Date: December 23, 2019

**ADDENDUM NO. 2**
To Project Bidding Documents for:

**A#03-119686**
**New Student Services Building**
**Compton Community College District**

tBP Project. No. 20987.00

PLUMBING SITE PLAN 1

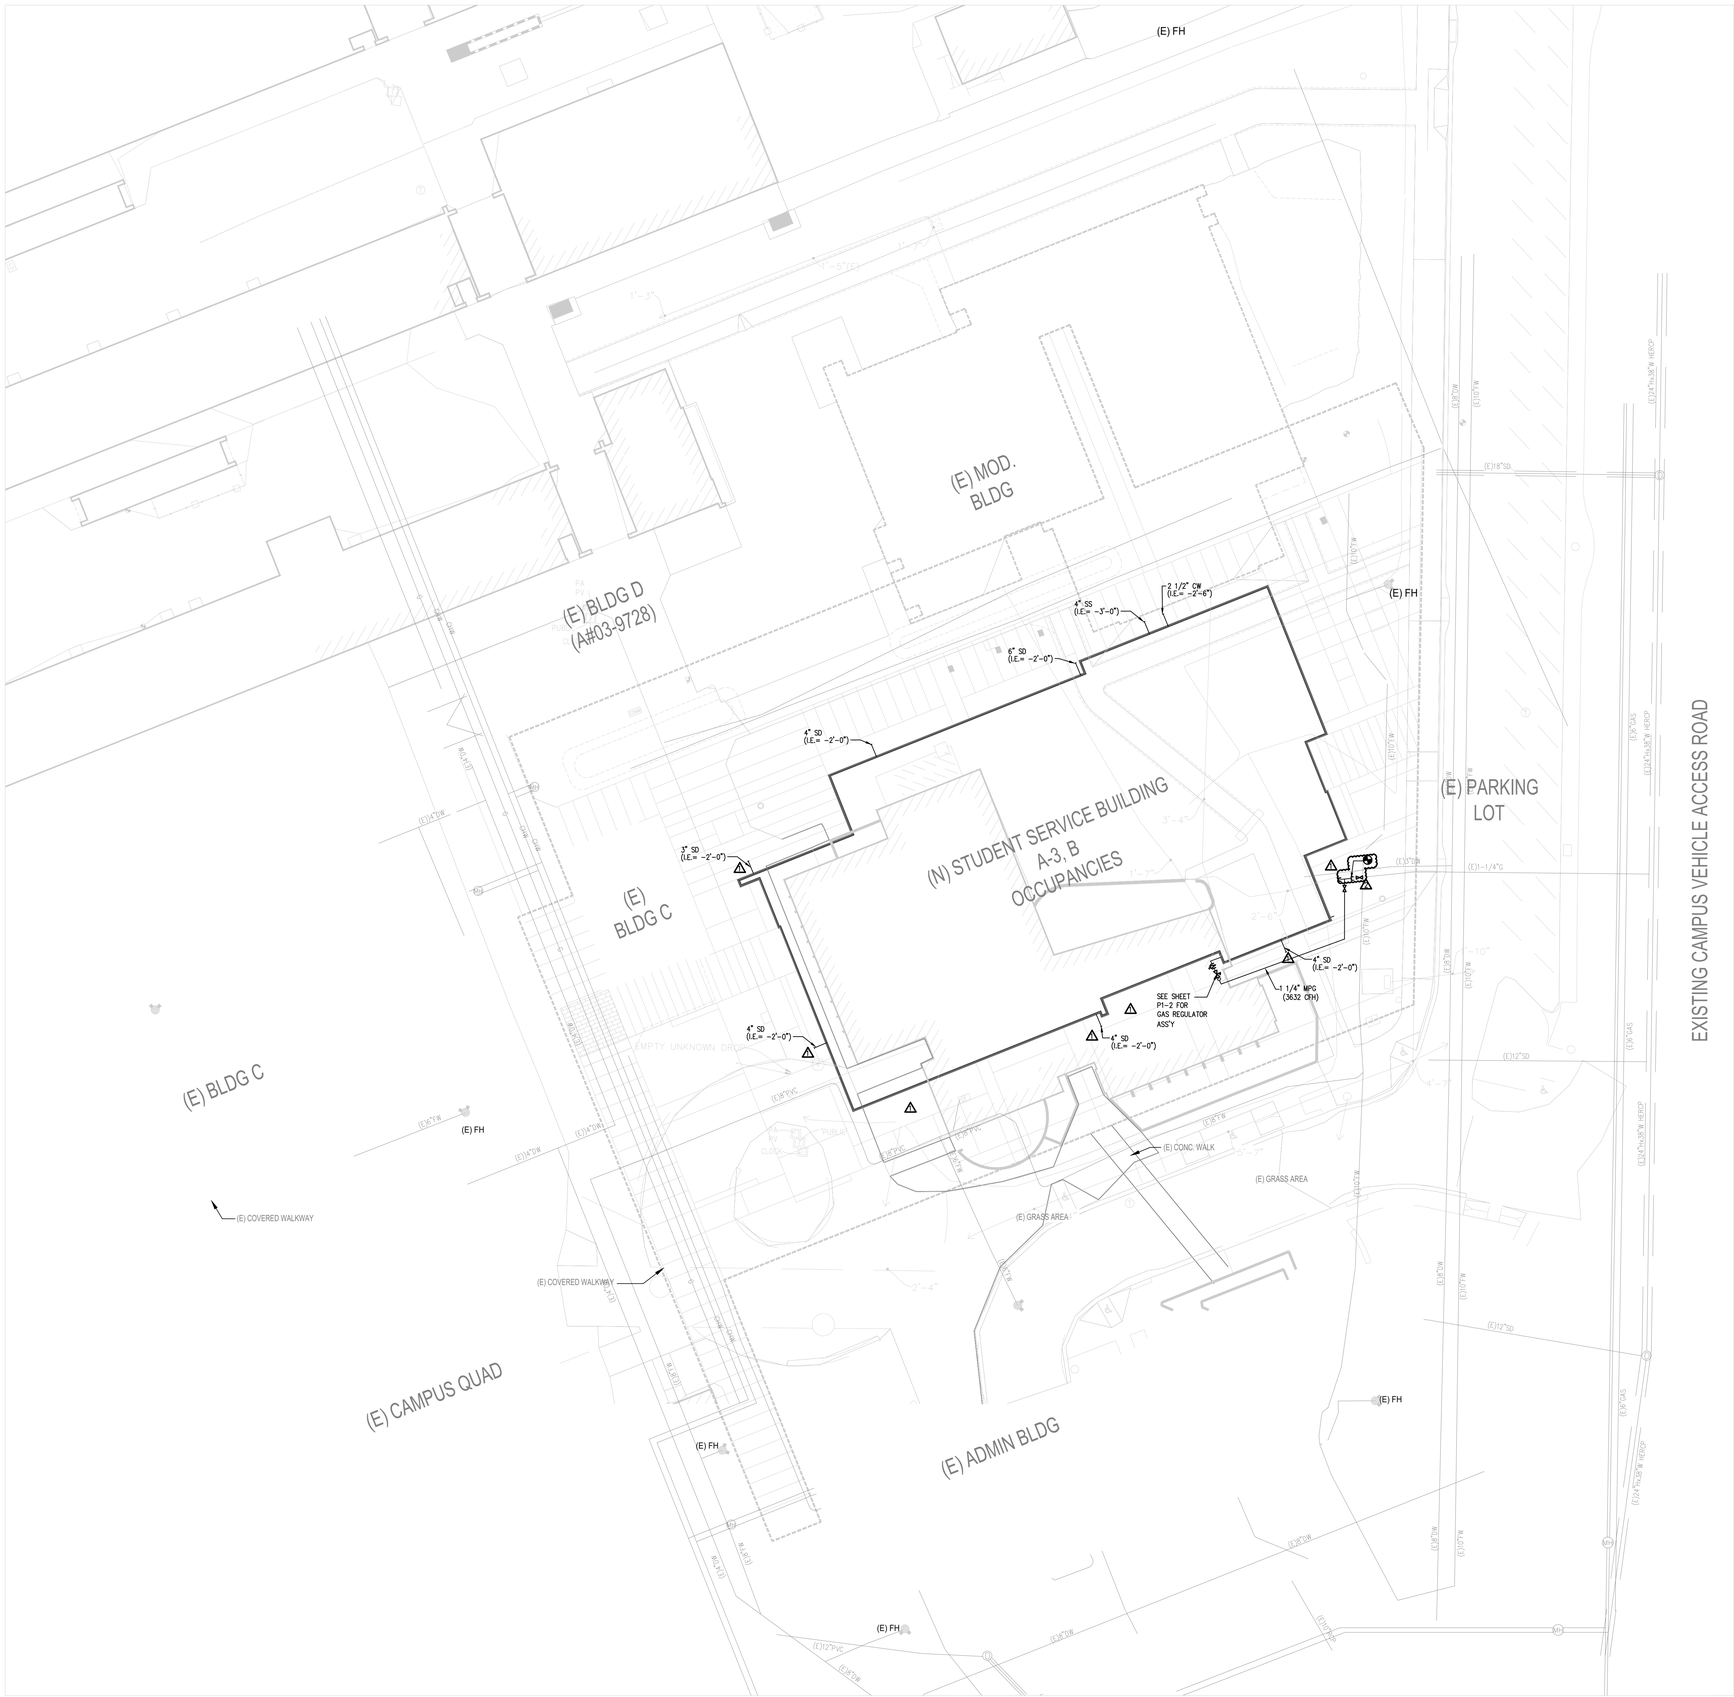
a. Added a gas valve at POC to existing after demolition of old.

ENLARGED FIRST FLOOR PLAN - RM 103, 104, 105, 109, 110 - GRAVITY

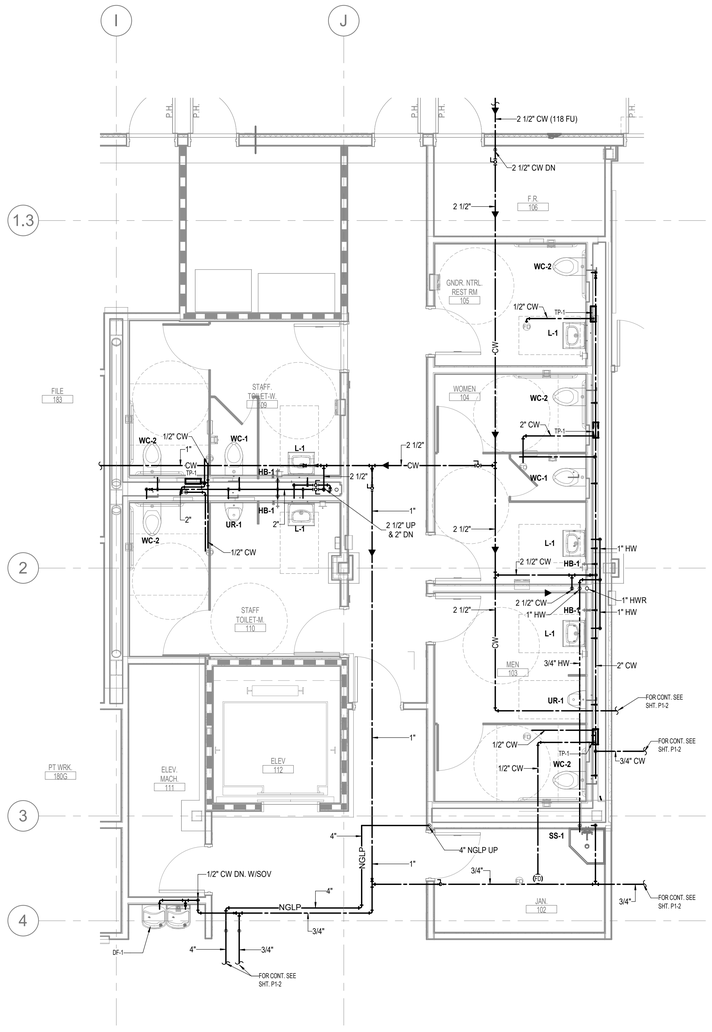
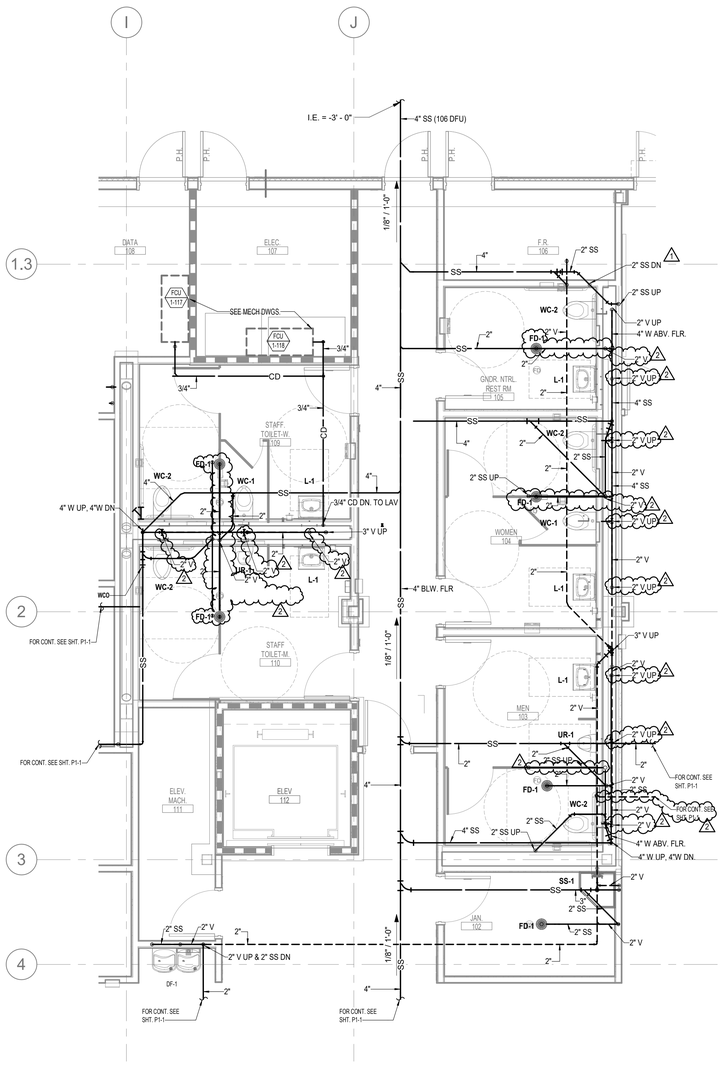
a. Modified vents on plan 1 in rooms
    b. Added FD-1 on plan 1 in rooms 104, 105, 109 & 110.
    c. Modified sanitary sewer routing in room 103, 109 & 110.

ENLARGED SECOND FLOOR PLAN - RM 202, 203, 207, 208, 209 - GRAVITY (1)

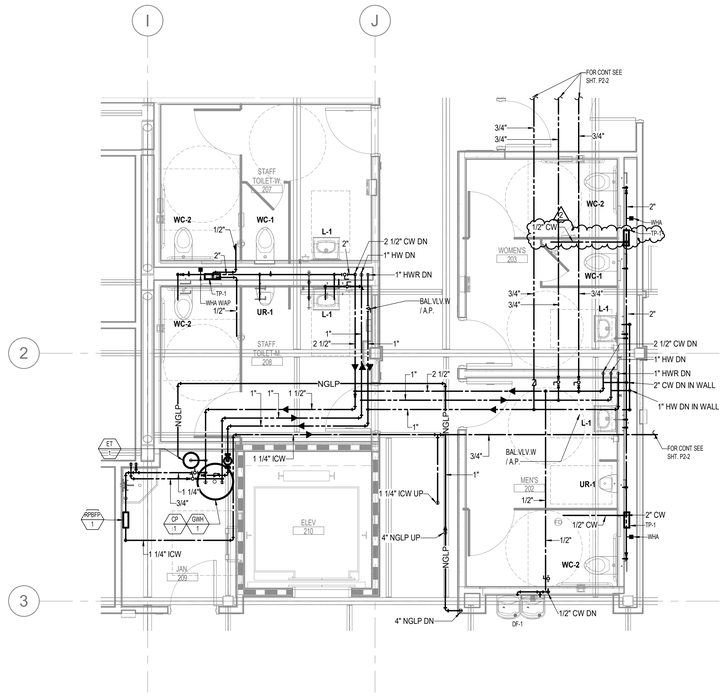
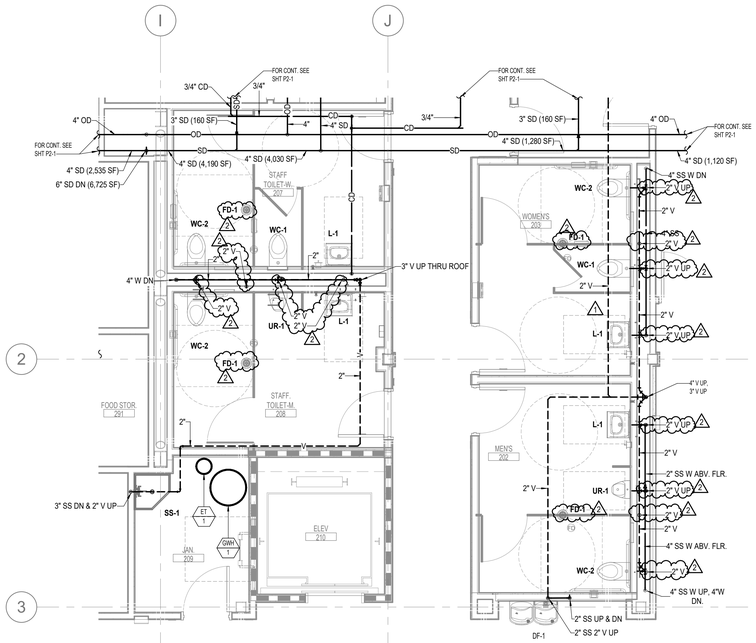
a. Added FD-1 on on Plan 1 in rooms 202, 203, 207 & 208.
    b. Modified routing of vent lines on plan 1.
    c. Modified cold water routing on plan 2 in room 203.

## SINGLE LINE DIAGRAM - STUDENT SERVICES

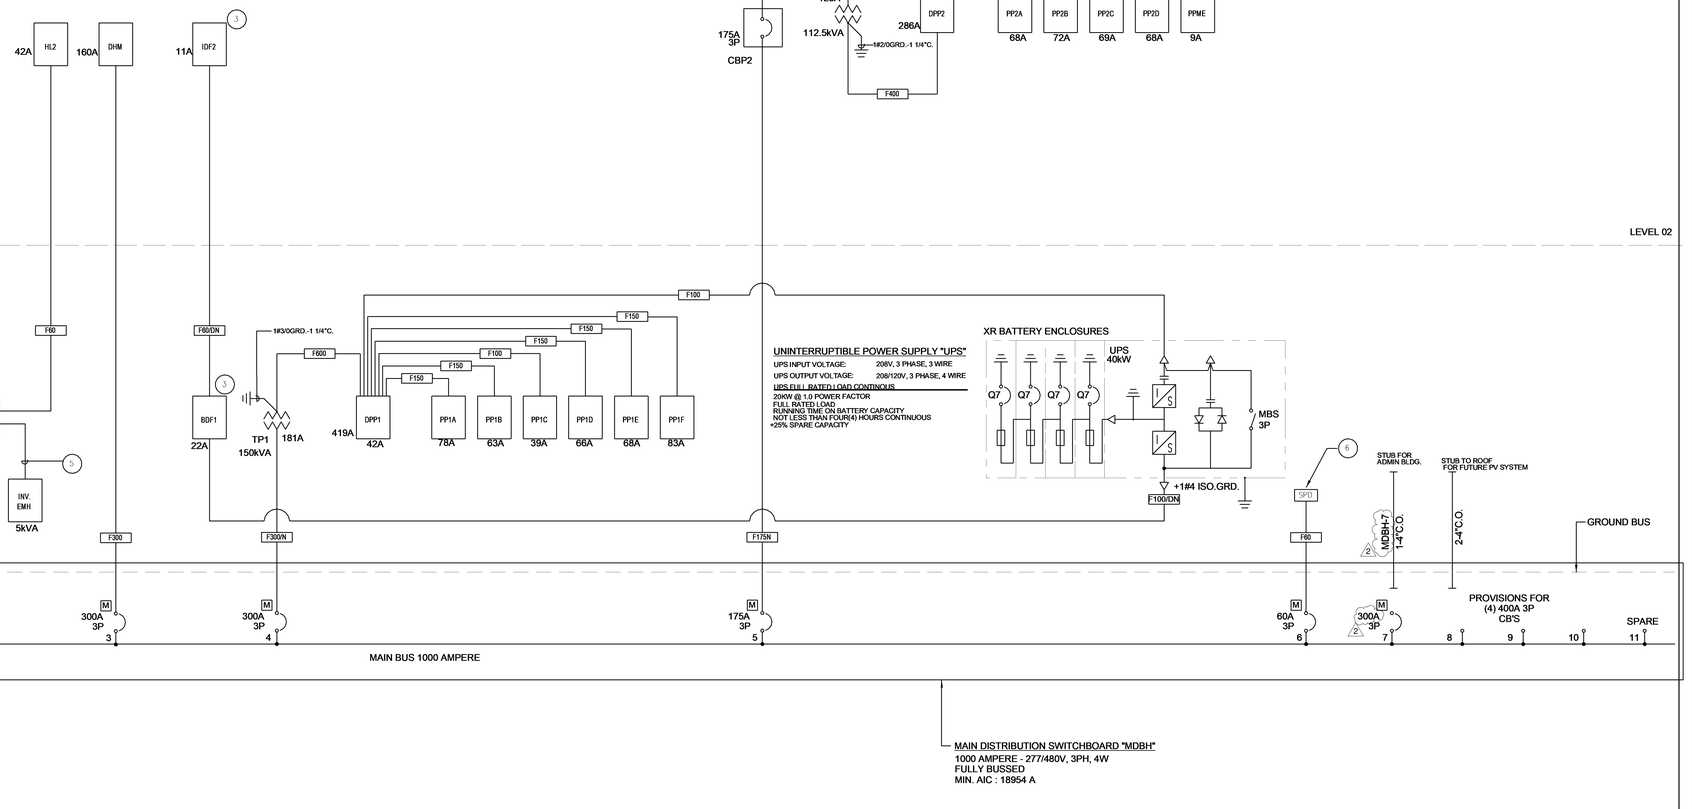
a. Revise note 2, delete Note 11.
    b. Change Circuit breaker size for “stub for Admin Bldg.”
    c. Change circuit breaker size for transformer “T-SS”.

drawing no.:
E2-1

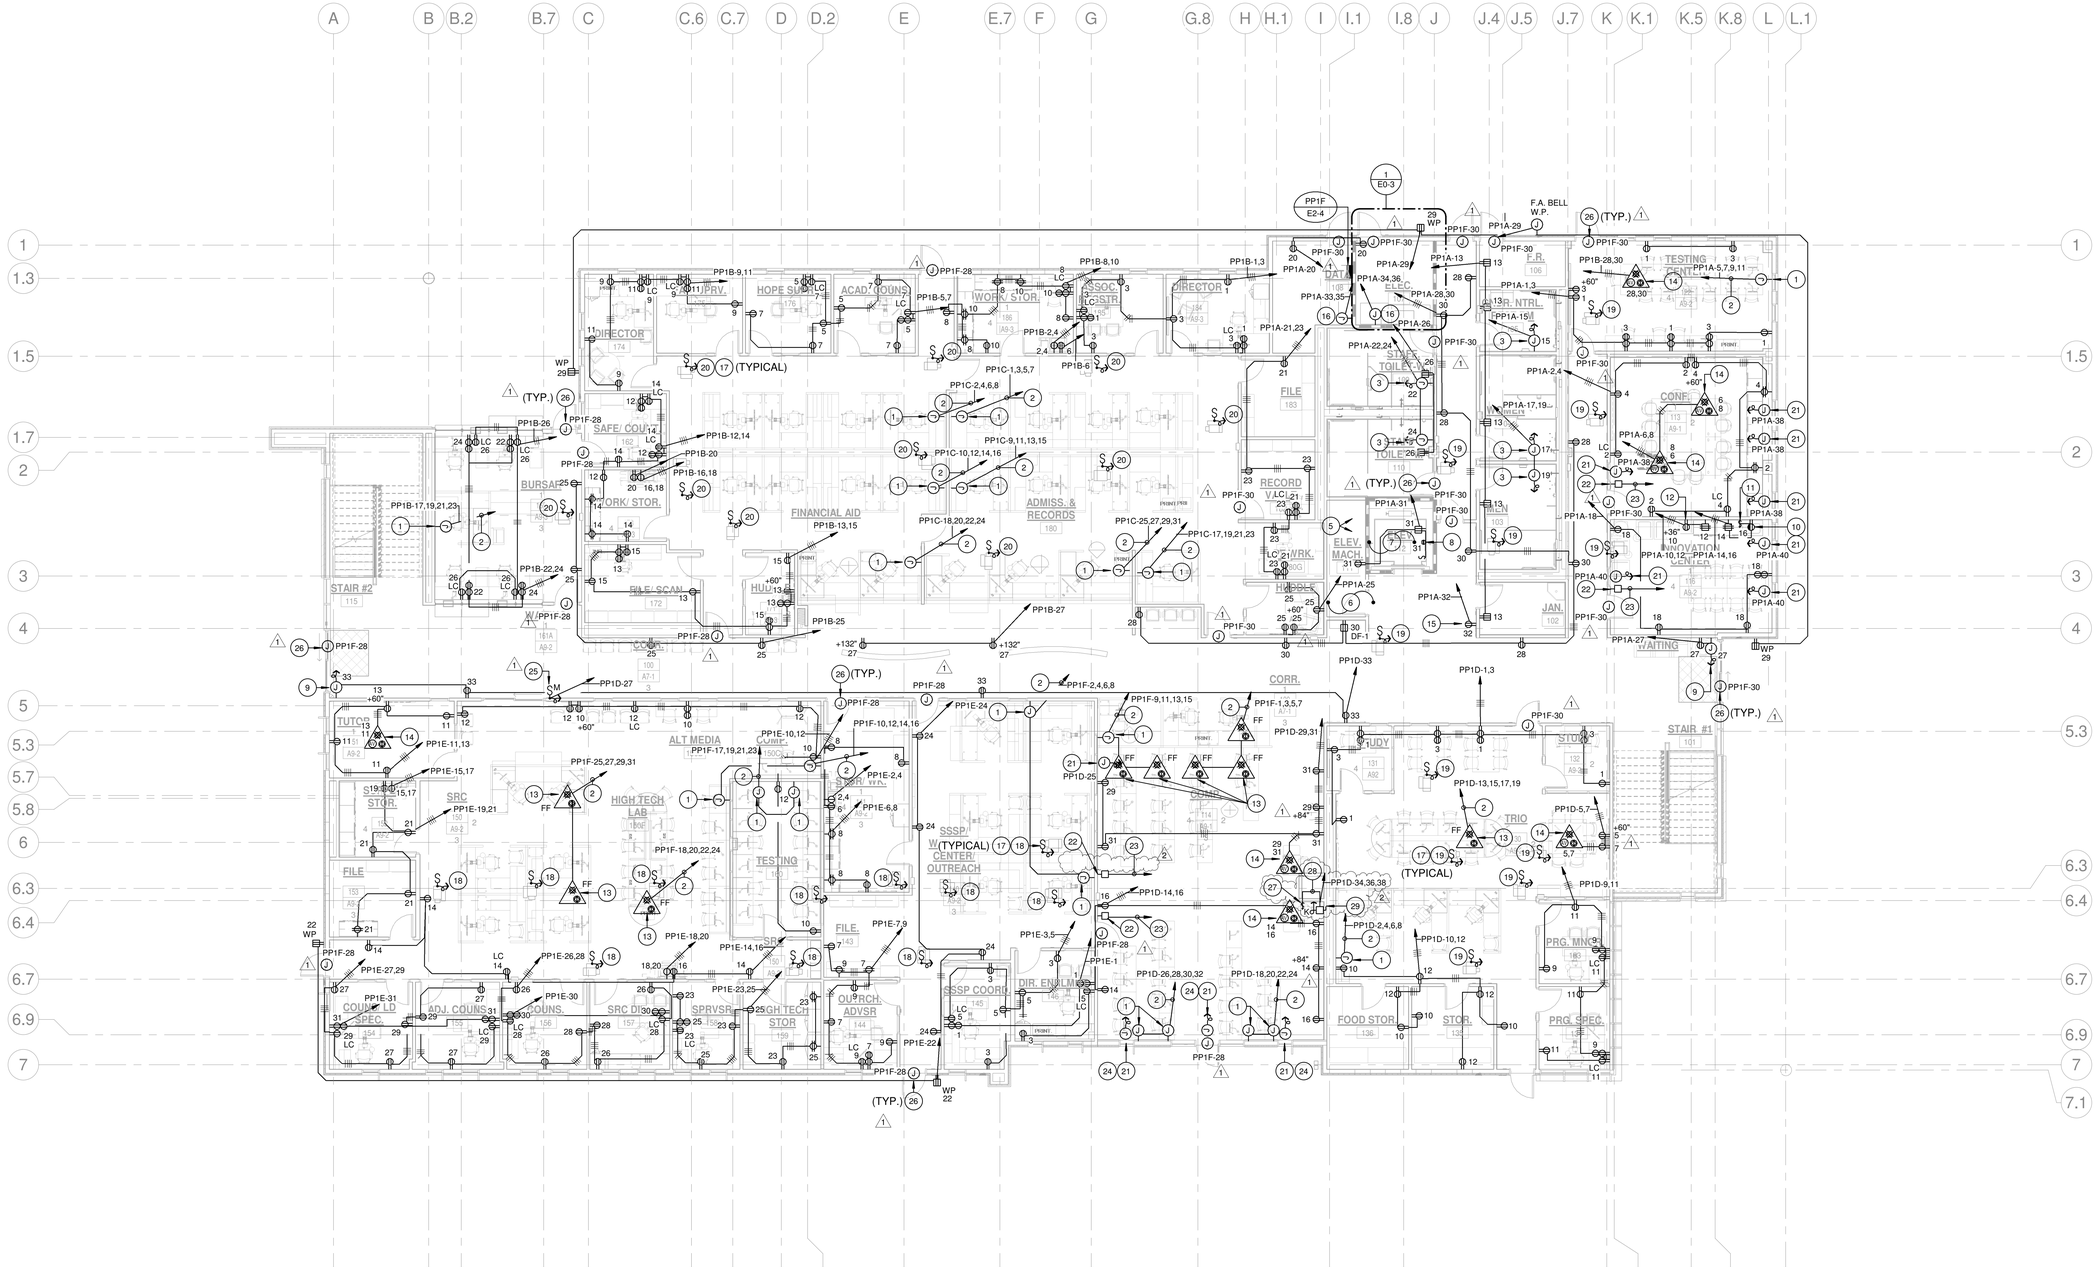
a. Remove power for shades at Comp 114
    b. Add Notes 27, 28 & 29
    c. Add power for electronic operable partition at Comp 114.
